From: Van Le-GHFL [mailto:vangooseneighborhood@gmail.com]
Sent: Sunday, March 20, 2016 5:15 PM
To: Planning and Sustainability Commission <psc@portlandoregon.gov>
Cc: Luke Gilmer <lukegilmer@gmail.com>; livability@goosehollow.org
Subject: TSP Testimony: GHF neighborhood association supports addition to bikeway network

I'm hoping that I can still add some feedback for addition to the Draft TSP report for proposed major city bikeway locations. A friend, reviewing the current TSP Update, Proposed Draft, dated Dec, 18th, 2015, let me know that I should contact you.

Map Proposal

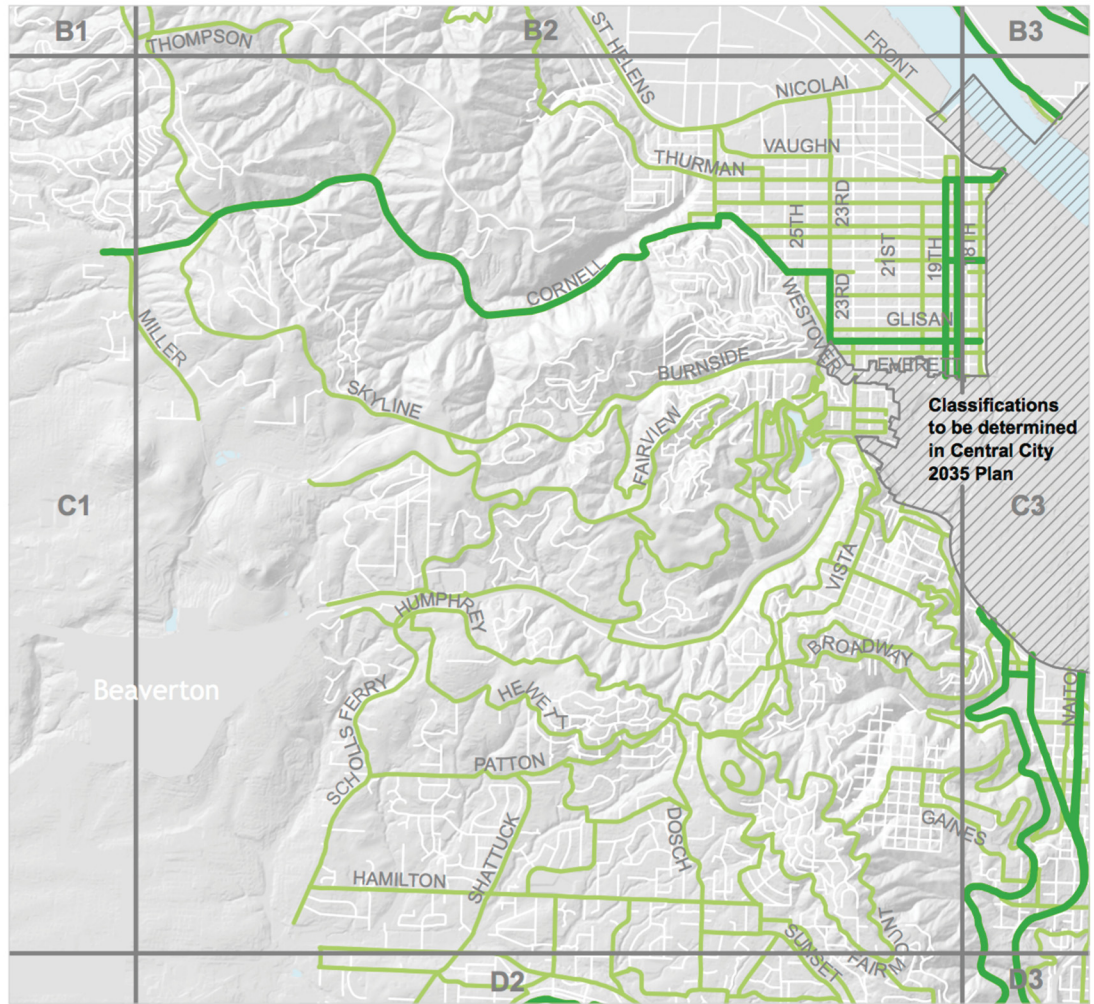
- *Enclosed in a copy of the trail from MapApp; the trail is shown as ‘light green’ along I-405 on lower southern edge.
- *Also enclosed is a copy of the pg 21, TSP Draft, Section 5: Bicycle Classification Maps, Area section C2; the trail is missing, but would connect Terwilliger and Barbur bikeways to the University District (South Park Blocks) and into central Goose Hollow.

Lower I-405 Trail
Project # 20171
Lead Agency PBOT
Estimated Cost \$500,000
Design and implement a pedestrian connection along I-405.

Proposed TSP Amendment

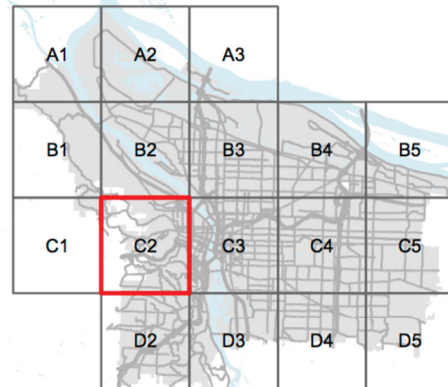
Proposed Bikeway Addition
